February 28, 2006

Subject: Docket Nos. 50-361 and 50-362
Proposed Change Number (PCN)-548, Revision 1
Battery and DC Sources Upgrades and Cross-Tie
San Onofre Nuclear Generating Station, Units 2 and 3

SUBJECT: Proposed Change No. 548, Rev. 1, is a request to revise Technical Specifications (TSs) 3.8.1, "AC Sources – Operating," 3.8.4, "DC Sources – Operating," 3.8.5, "DC Sources – Shutdown," 3.8.6, "Battery Cell Parameters," 3.8.7, "Inverters – Operating," and 3.8.9, "Distribution Systems – Operating." This change will also add a new Battery Monitoring and Maintenance Program, section 5.5.2.16. This change will extend the Completion Time for an inoperable subsystem battery by allowing manual cross-connect of distribution subsystems, upgrade to the 2002 Revision of IEEE 450, include improvements included in Revision 1 to Technical Specification Task Force (TSTF) – 360, and make editorial modifications more consistent with industry use.

Attachment 2: DC System Configuration Diagrams (Sketch 1 and 2)**Proposed Train A DC System Reconfiguration****Proposed Train B DC System Reconfiguration**

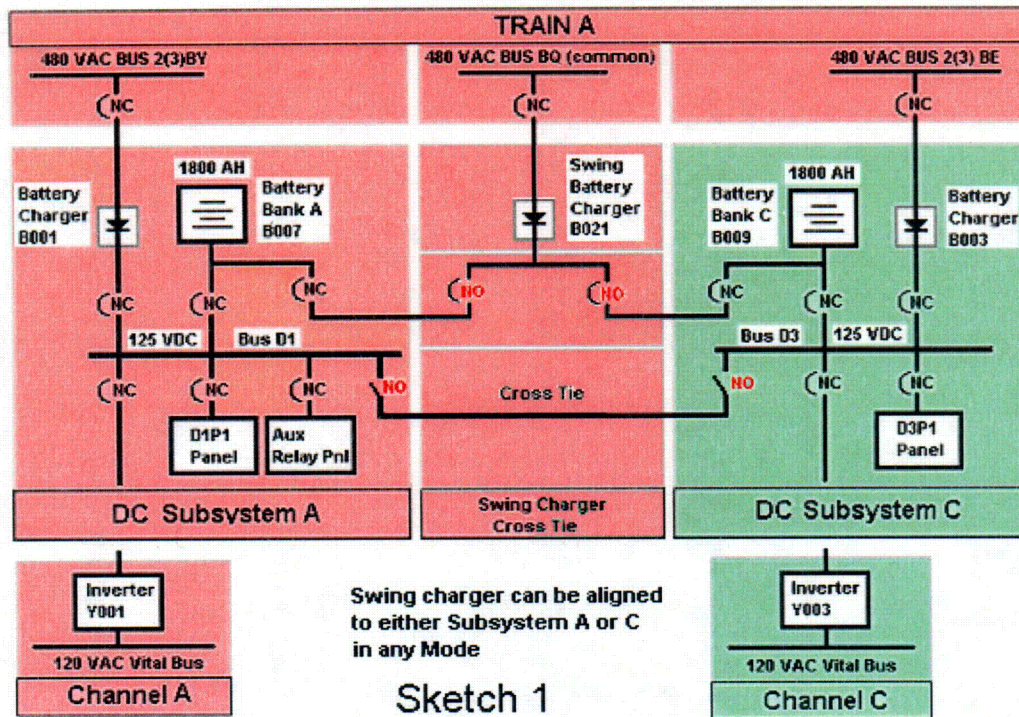
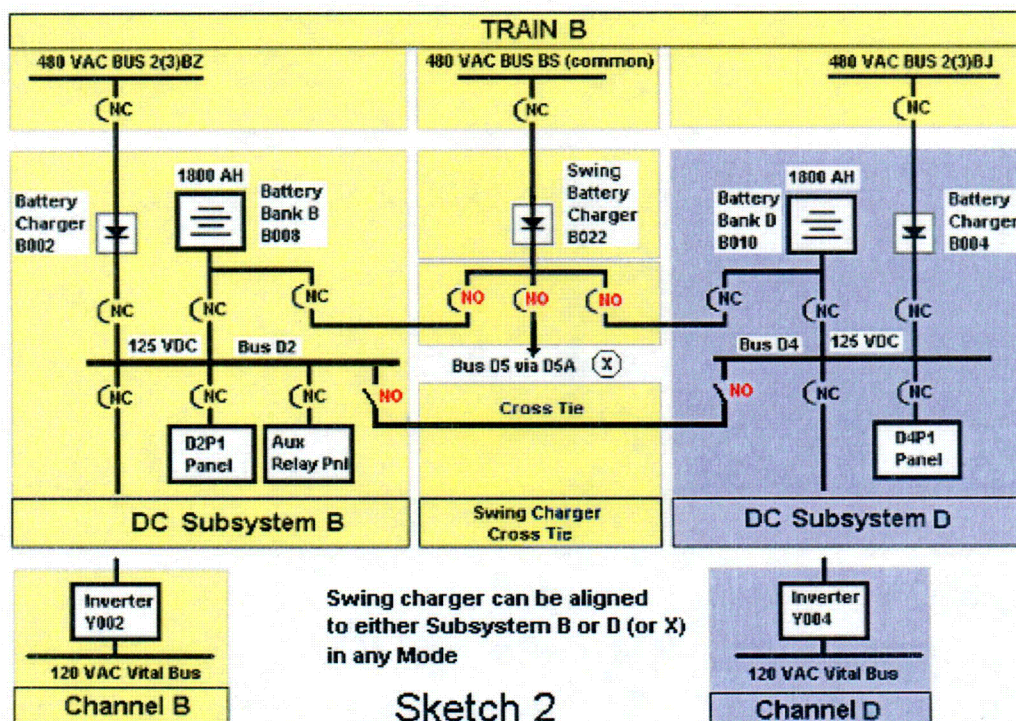
The DC system is currently being upgraded by SCE to replace each of the existing batteries with larger 1800 amp-hours (AH) rated batteries, add two 400 Amp rated swing battery chargers and 600 Amp, 250 Volt rated disconnect switches, and upgrade several circuit breakers in DC switchboards and distribution panels (refer to attached Sketches 1 and 2 in Attachment J of Train A and Train B systems, respectively). One swing battery charger will be shared between DC subsystems A and C, and a second swing charger will be shared between DC subsystems B and D. The second swing charger can be aligned to the non-safety-related bus D5. Each swing battery charger will have mechanically interlocked, dedicated DC circuit breakers to allow it to feed only one subsystem at a time. An additional 600 Amp circuit breaker is interposed between the swing battery charger and the associated battery bank for separation and isolation. SCE has installed a new Class 1E 1800 AH rated spare battery bank (B00X) so that replacements of the existing batteries (e.g., at end of battery service life) can also be performed online. When B00X is no longer needed, it will be removed from the plant.

To be able to fully utilize the flexibility provided by the proposed TS, design changes are currently being made to the electrical system to provide the ability to manually cross-connect DC subsystems during operating Modes 1-4 and continue to meet General Design Criteria (GDC) 17, GDC 18, Regulatory Guide (RG) 1.6, and IEEE 308. These design changes include one new swing battery charger to be shared by subsystems A and C and another by subsystems B, D, or non-1E bus D5. Electrical isolation and independence between subsystems required by RG 1.75 is maintained by the isolation capability of the battery charger itself and the kirk key interlocked output circuit breakers. The existing batteries for each train are being replaced with batteries with 1800 amp-hour ratings. (Refer to Sketches 1 and 2 of the post-modification system in Attachment J, Review Aid). Currently, the subsystems A and B batteries are rated 1260 amp-hours nominal 8-hour, and the subsystems C and D batteries are rated 1800 (previously 1500) amp-hours nominal 8-hour.
